IMPORTANT SAFETY NOTICE Concerning SPERIAN Warrior SCBA Heads-Up Display (HUD) Cable Connection

December 2, 2008

Figure 1 Old cable assembly.

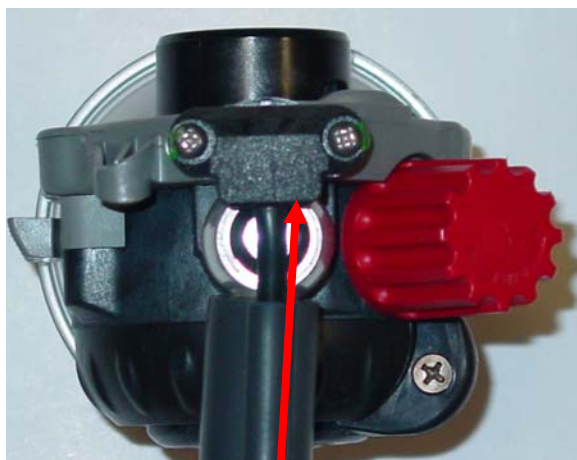
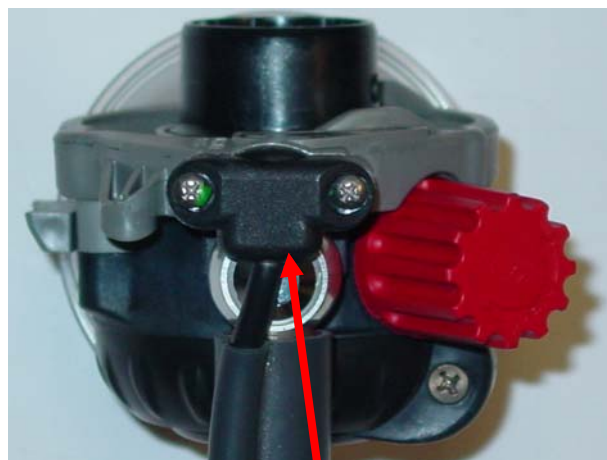
Sperian has determined through examination of some WARRIOR warranty returns that HUD lights did not work correctly. The cause was determined to be the cable assembly that attaches to the HUD. While this condition has been seen on fewer than 1% of Warriors shipped, and there have been no injuries reported, the cable assembly has been redesigned to eliminate this potential problem. Figure 1 below shows the original cable assembly and Figure 2 shows the new cable assembly. Note that the new cable connector has a rounded edge where the old cable connector had a square edge.

Old connector
Square edge

New connector
Rounded edge

Sperian will replace under warranty the cable assemblies on all WARRIORS that were made with the old cable assembly.

Examine the cable assembly connector and determine if your WARRIORS have the old cable assembly. If they do, contact a Sperian warranty center to arrange to have the cable assemblies replaced. (Note that Sperian technicians certified for Panther repair, but not yet certified for WARRIOR repair, are authorized to make this repair, because the procedure for replacing the WARRIOR HUD cable/hose assembly is the same as for the Panther.)
